# REGIONAL REVIEW NOTICE

ARC REVIEW CODE: R1705231

**Name of Proposal:** Herndon Homes (DRI 2677)

**HERNDON HOMES DRI**  
**City of Atlanta**  
**Natural Resources Division Review Comments**

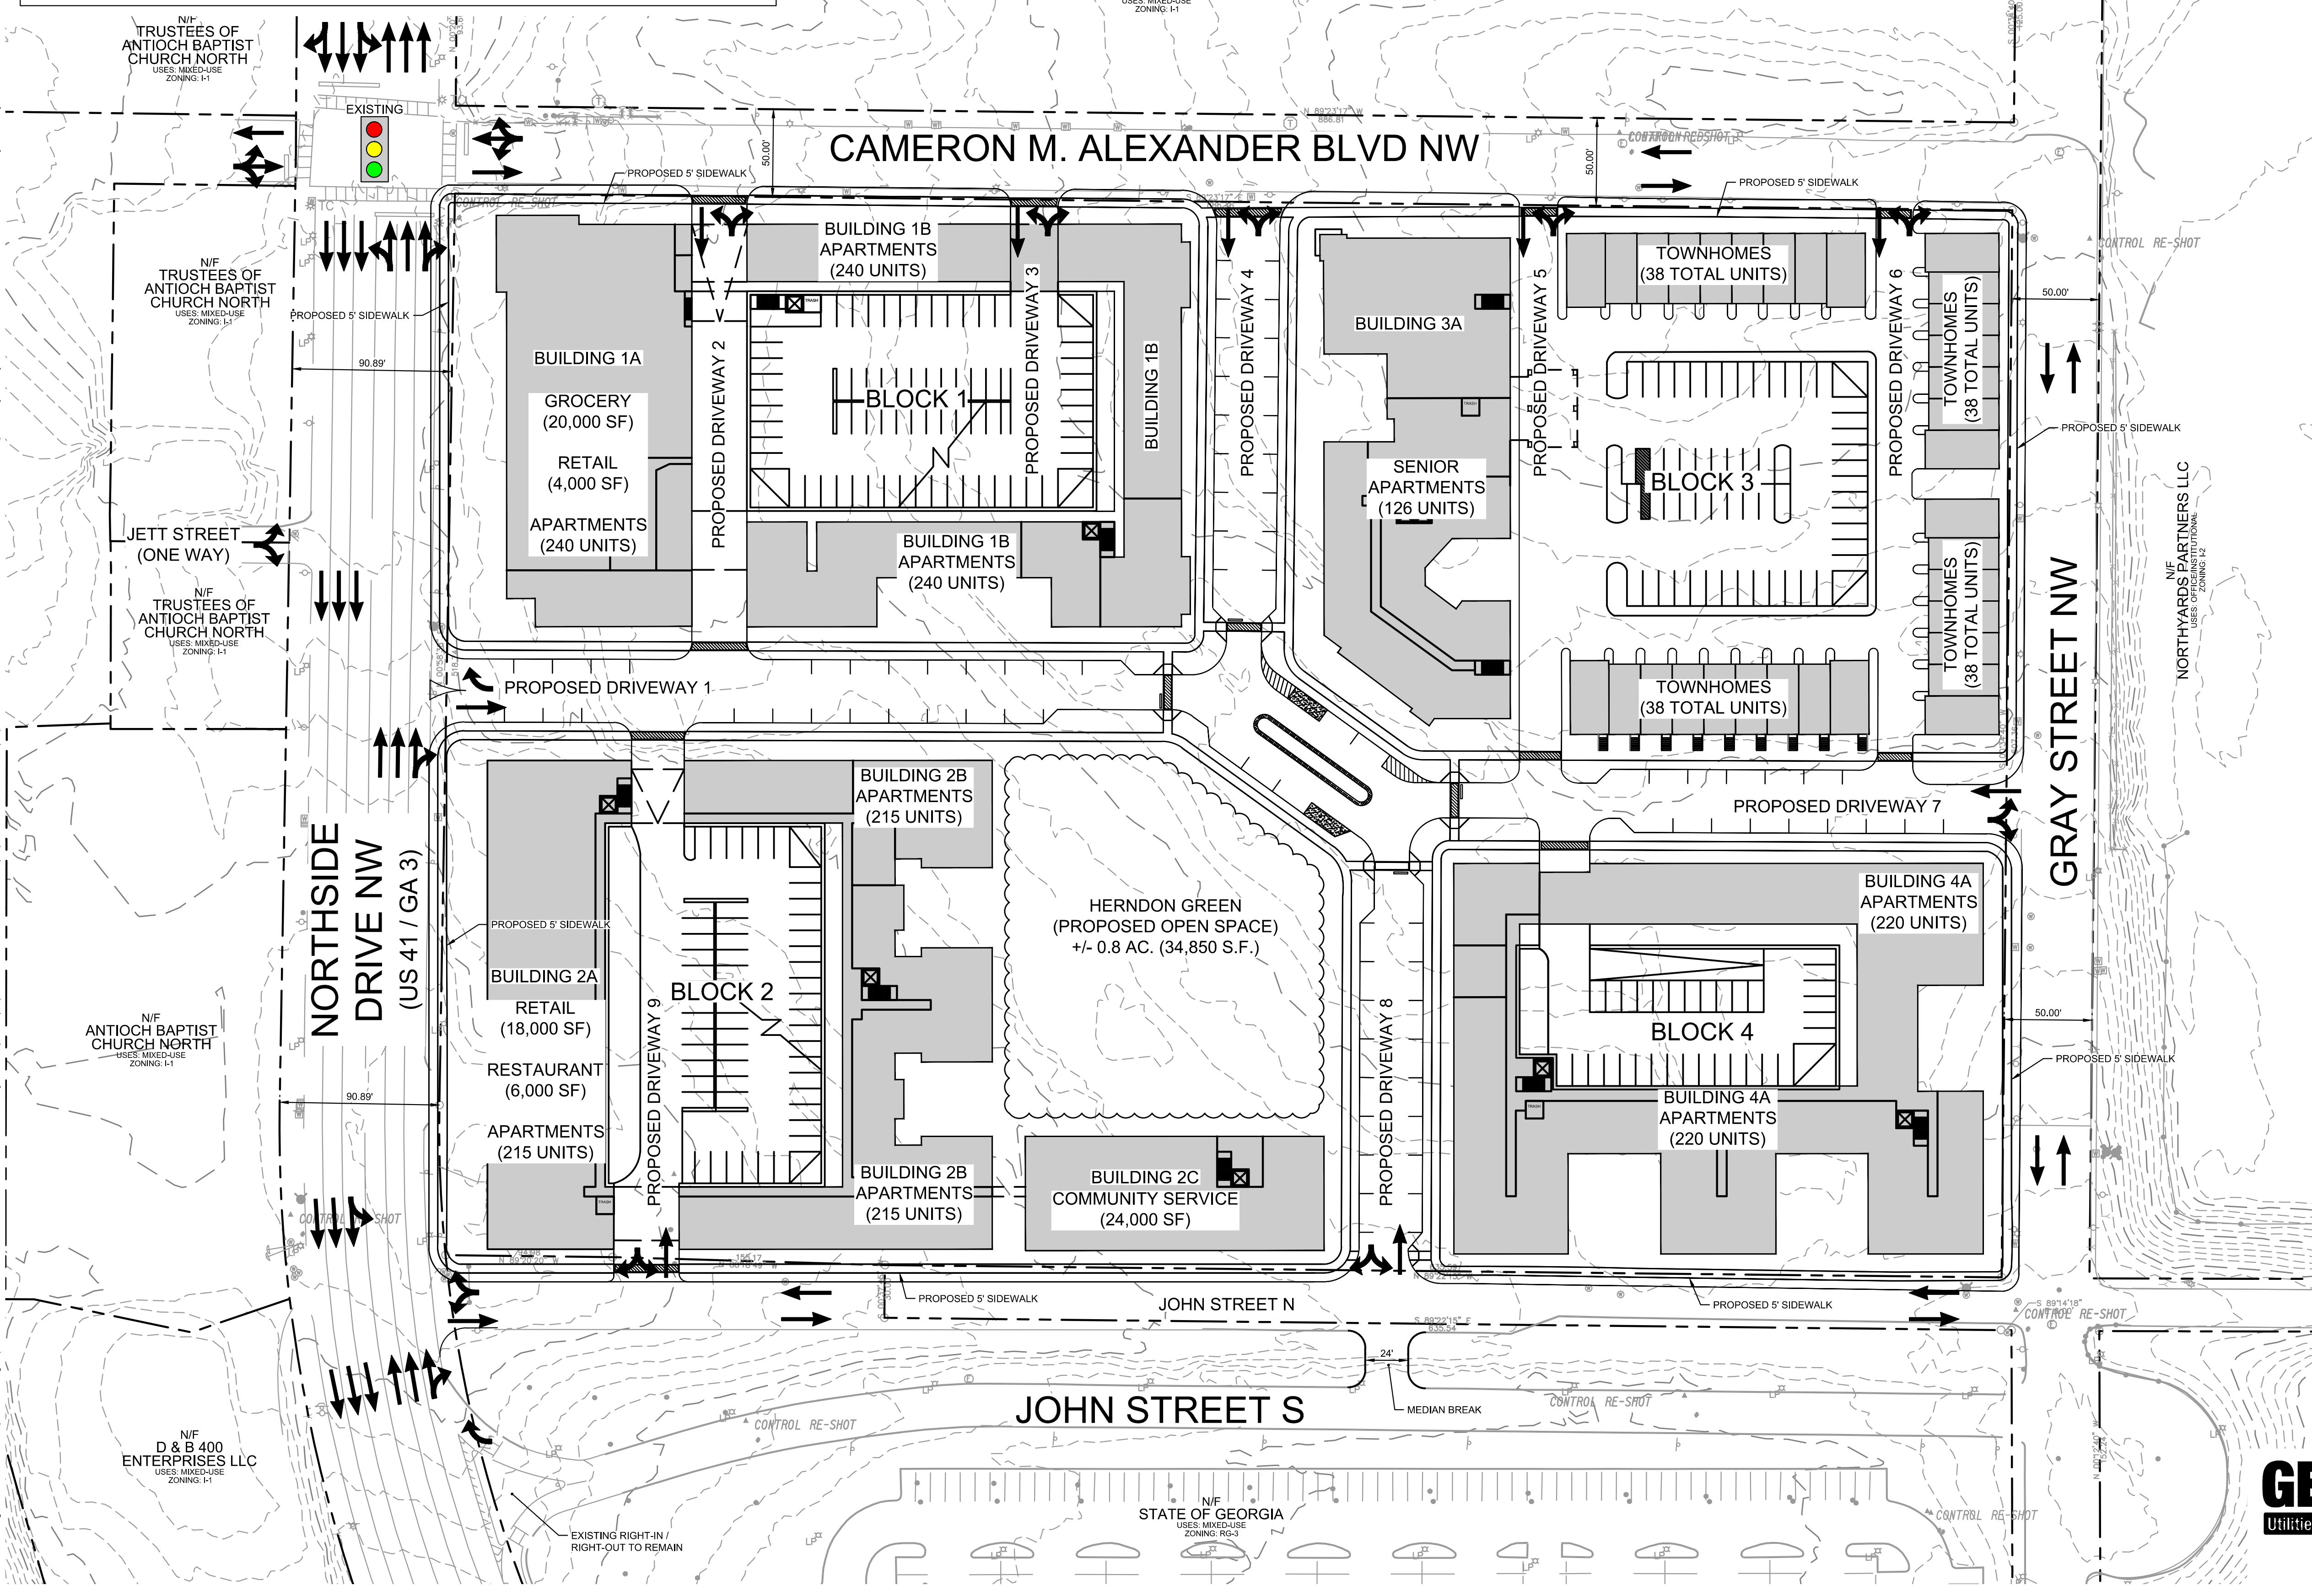
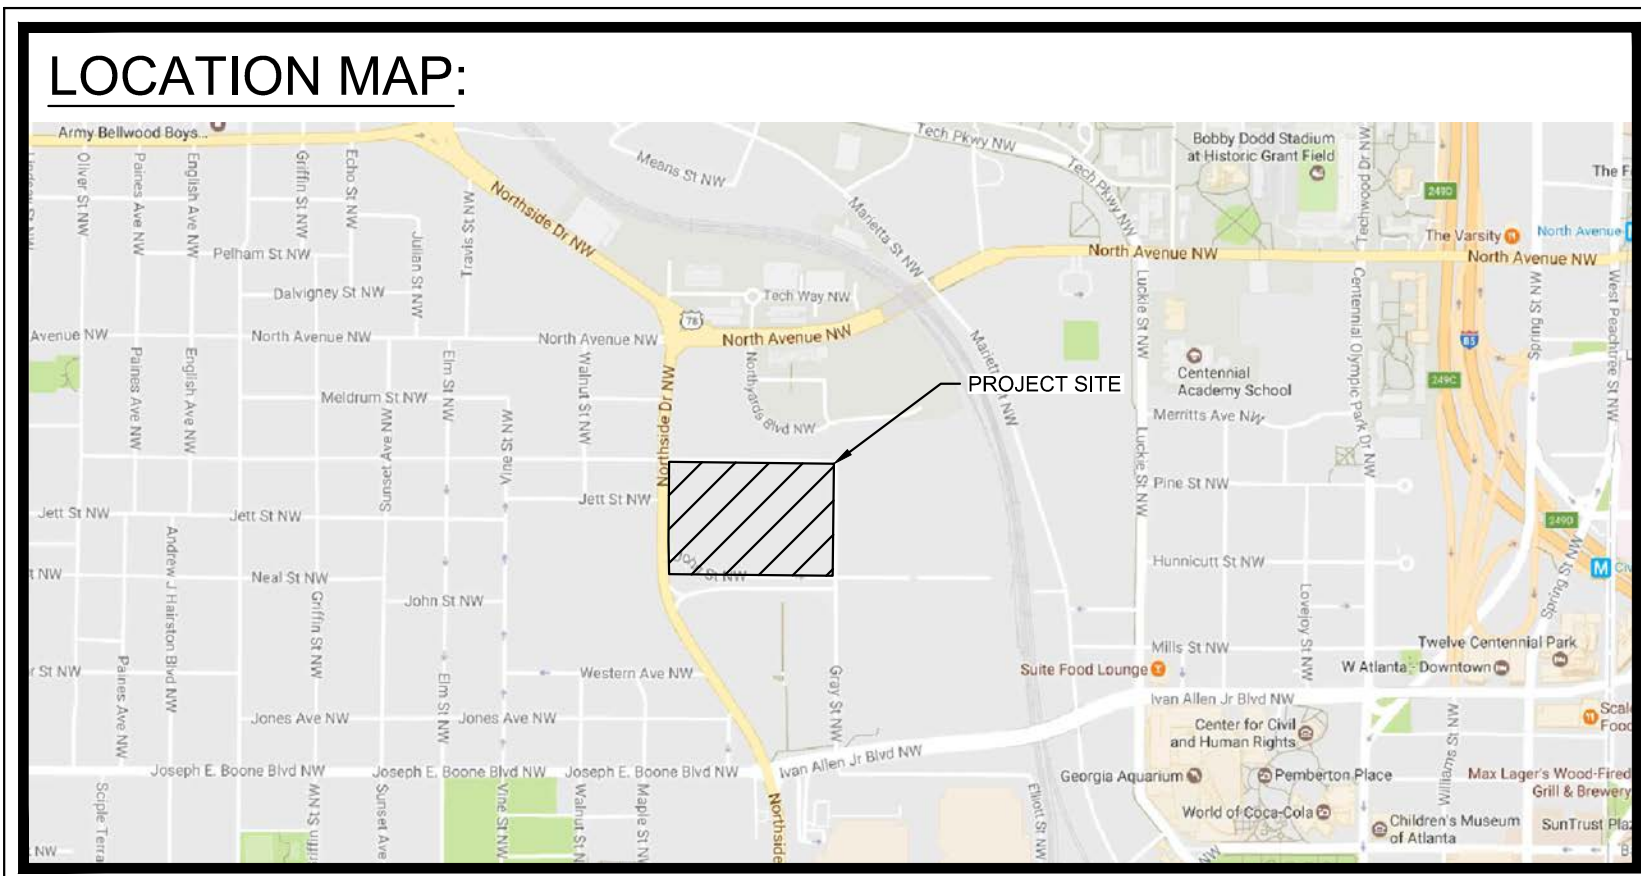
The site plan and traffic analysis identify one (1) proposed driveway off Northside Drive, a state route and eight (8) additional access points off John Street, Gray Street and Cameron Alexander Blvd, all local roads

The development site is located a 12.5 acre parcel bounded by public streets on all four sides. Adjacent parcels on the east, west and south are currently developed. An undeveloped parcel is located to the north of the site; the two parcels are separated by Cameron M Alexander Blvd, a local roadway. The site plan depicts five access points on Cameron M Alexander Blvd.

The site plan and traffic analysis does not indicate bicycle and pedestrian facilities being provided throughout the 12.5-acre development site. Sidewalks currently exist on all adjacent roadways with partial sidewalks on John Street. The site plan indicates sidewalks and crosswalks being provided throughout the development allowing for pedestrian connectivity throughout the site.

In the interest of safety, the number of access points proposed on Cameron M Alexander Blvd should be reduced.

As a note regarding accessibility of services, senior housing is more than 600 feet from the nearest bus transit stop on the west side of Northside Drive at Cameron Madison Blvd, more than 400 feet from the retail (grocery store) with apartments (240 units) separating the uses. With seniors least likely to drive and the dependency of alternative modes use on the site, senior accessibility to uses should be considered.
